Staff Report Presented to the Planning Commission

REQUEST: The applicant is seeking a variance to allow ~~lot width to be measured from property lines as opposed to an easement(s) boundary for Lots 21—29 and to allow 34 15 percent (i.e., 9 4 lots) as opposed to 10 percent of lots within the proposed subdivision to be accessed by private access easement.~~ ~~Lot Depth and Width: Where required by the underlying zone, the lot width shall be measured along the easement boundary and the lot depth shall be measured from the easement boundary to the rear lot line. [SHMC 17.42.120(C)].~~ No more than 10% of the lots within a subdivision may be accessed by a private street or private access easement. [SHMC 17.58.030(C)(3)]. The subject property is zoned Residential Low Density (R-1). The Comprehensive Plan Designation is Low Density Residential (R-1).

FILE NUMBER: VR24-01

PRELIMINARY LOT PLAN
 TAX MAP: 13S01E32CA
 LOT: 04403
 SWEETHOME, OREGON

SCALE: SEE BARSCALE
 SHEET: C101B

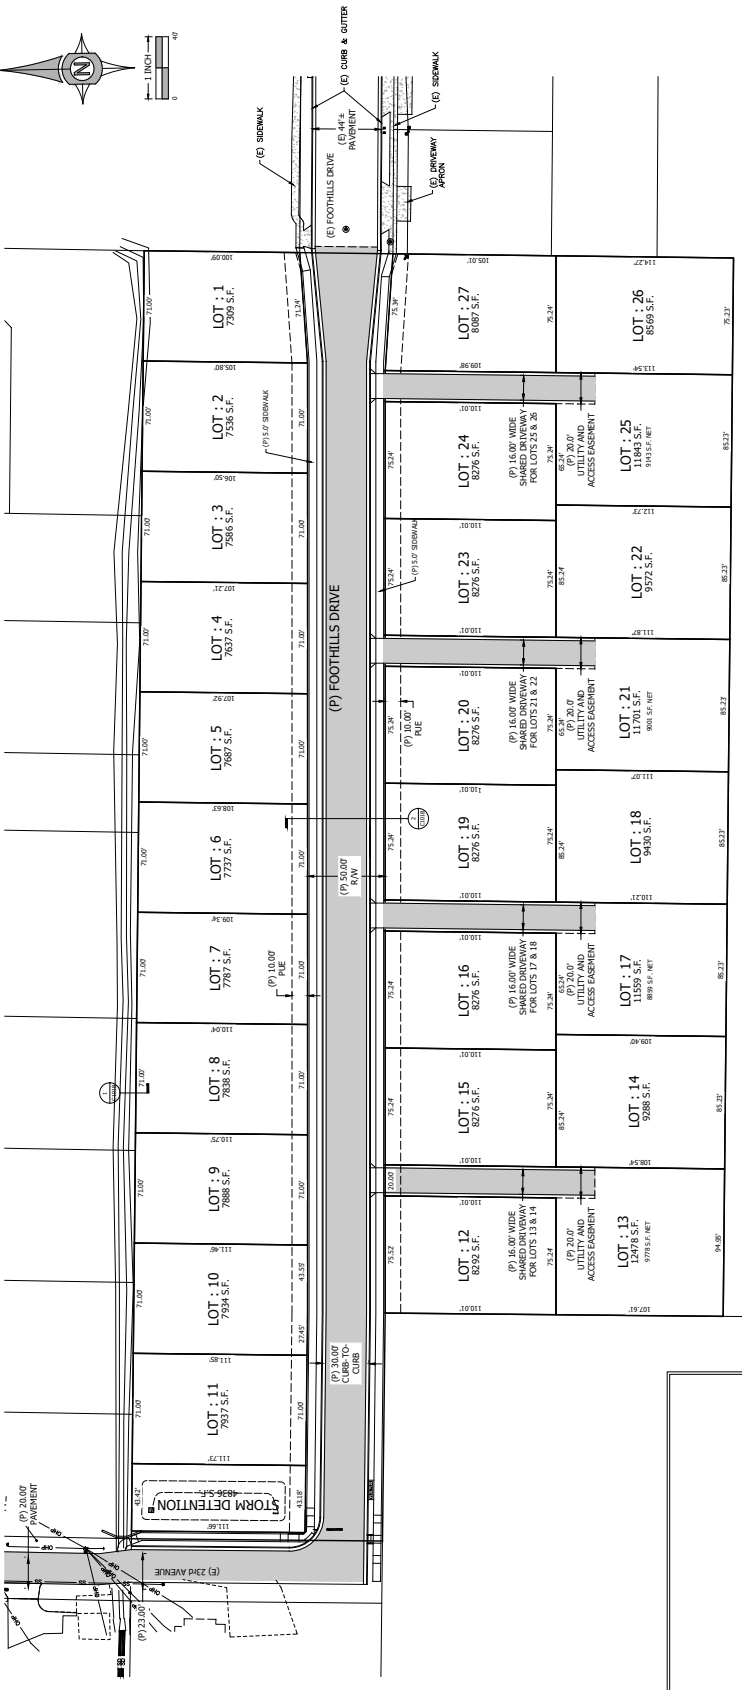
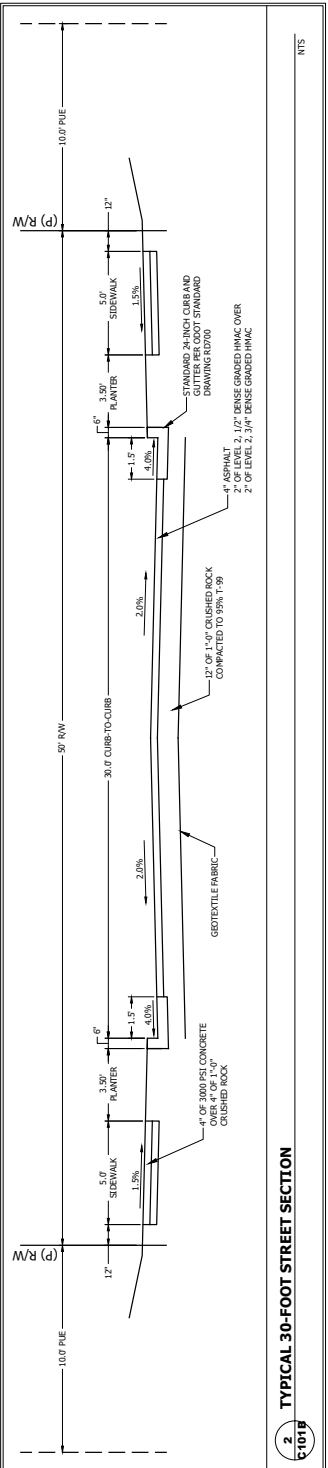
Additional Comments regarding the amended site plan, emailed on August 27, 2024: No utilities are shown, so hopefully they can show me the corrections I needed to see. What's more, it looks to me like our future water tower easement that ran through lots 26 & 27 is completely gone now, additionally, no outlet easement is shown from storm detent to ditch north of the subdivision.

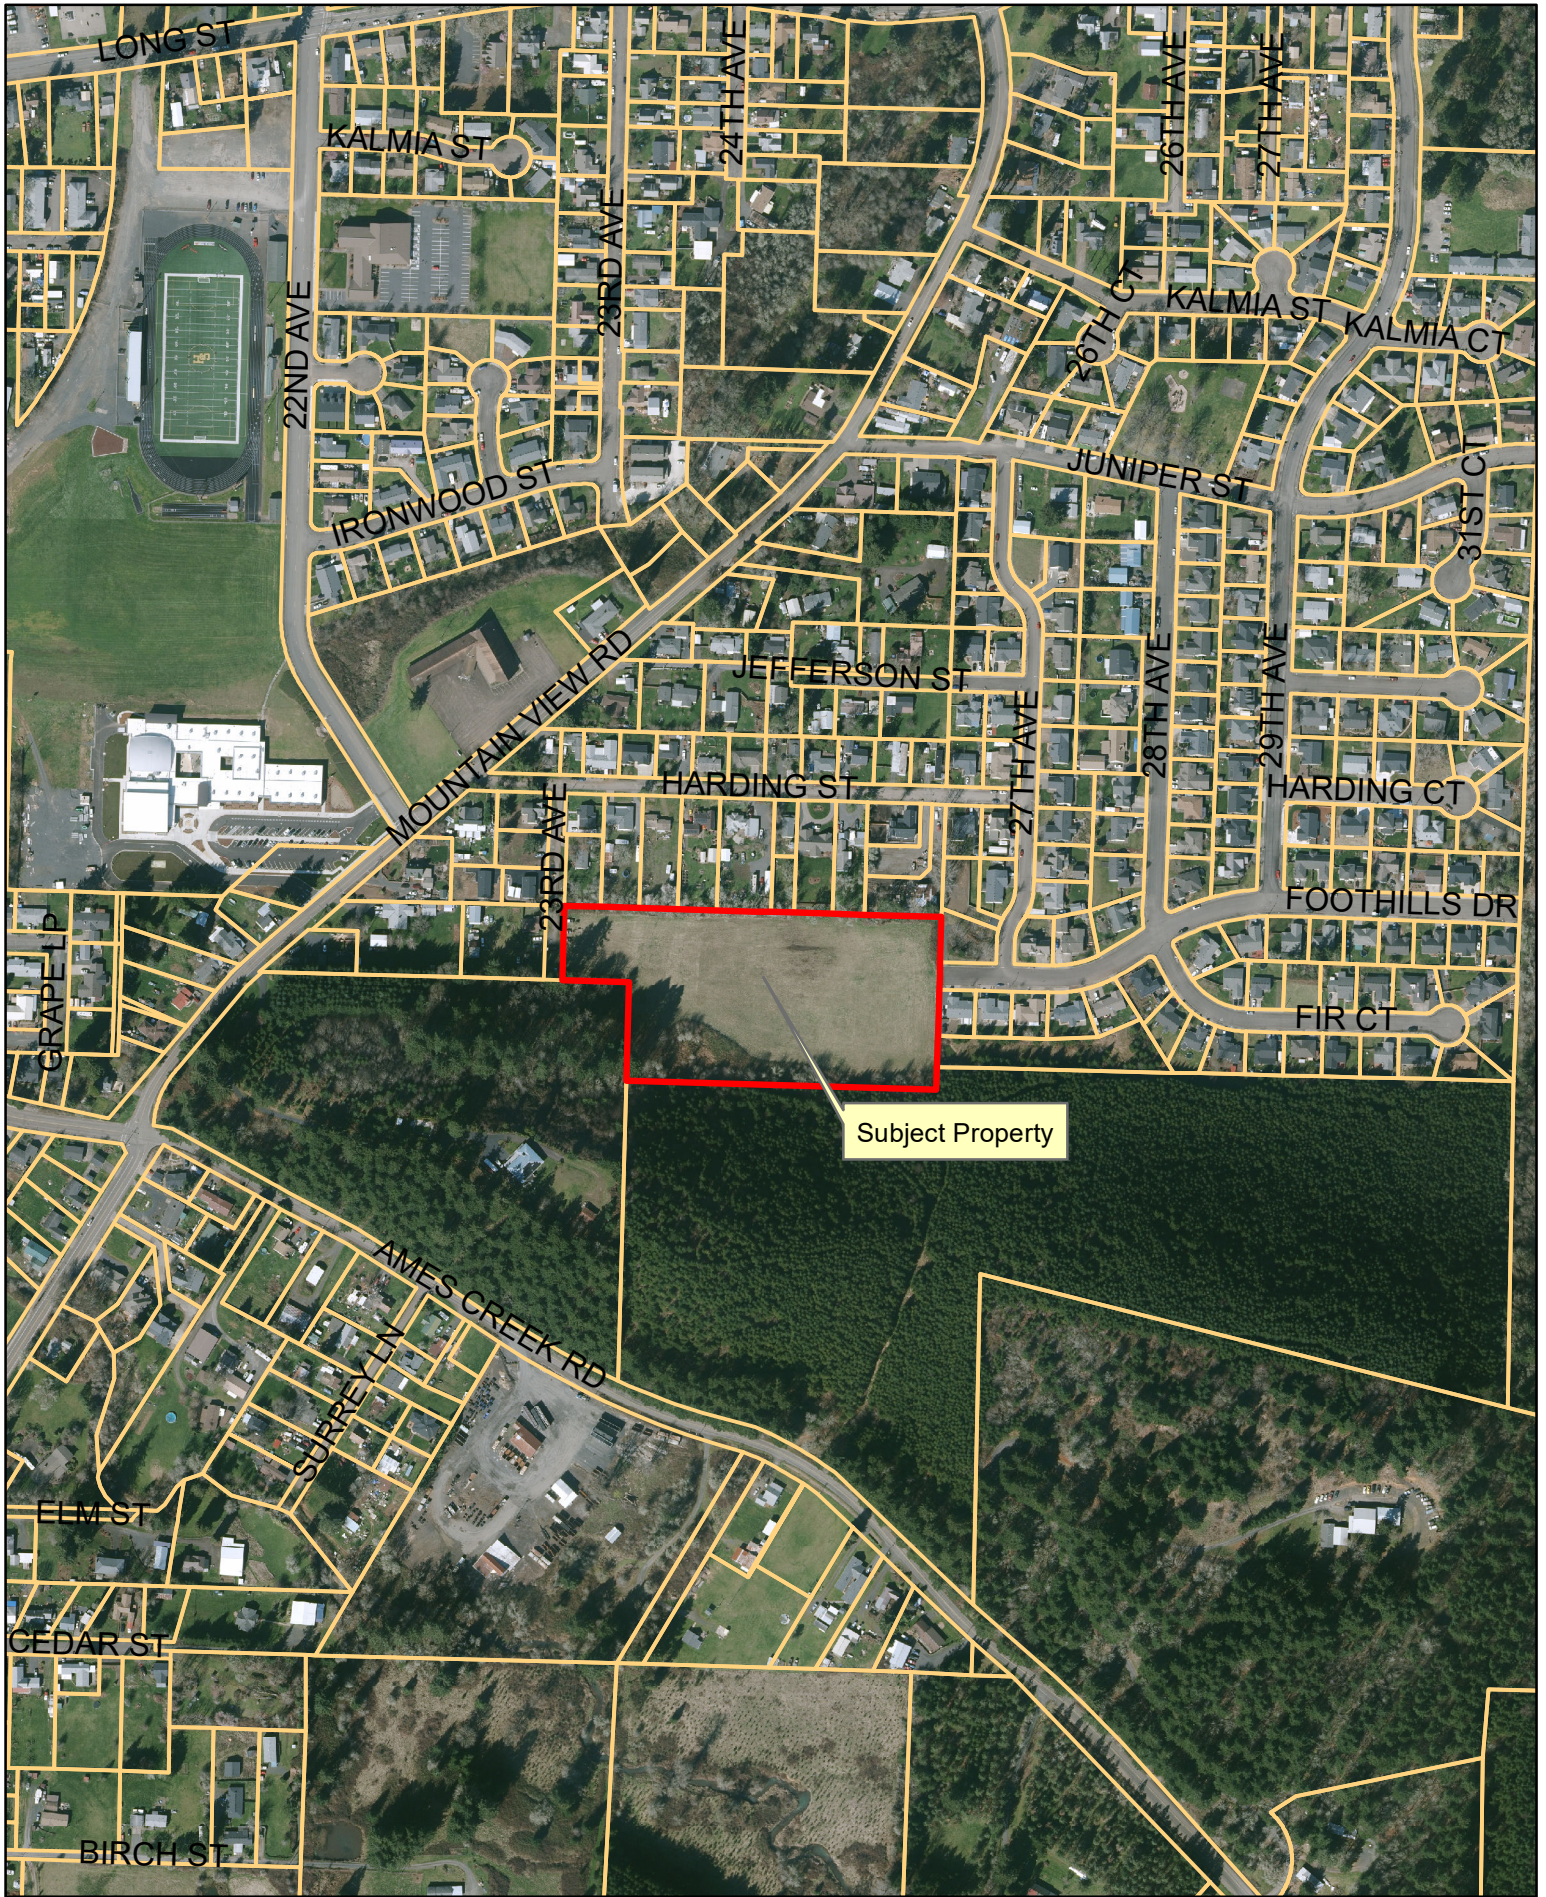
Sorry for the delay on this. Attached is an alternative lot layout for this subdivision. In this layout lots 13, 17, 21, and 25 are flag lots and lots 14, 18, 22, and 26 are access via easement. The 10% standard for subdivision lots accessed via easement is only slightly exceeded in this scenario (3 lots vs. 4 lots proposed and 10% vs 15% proposed). Additionally, the variance request for the lot width measurement is no longer necessary.
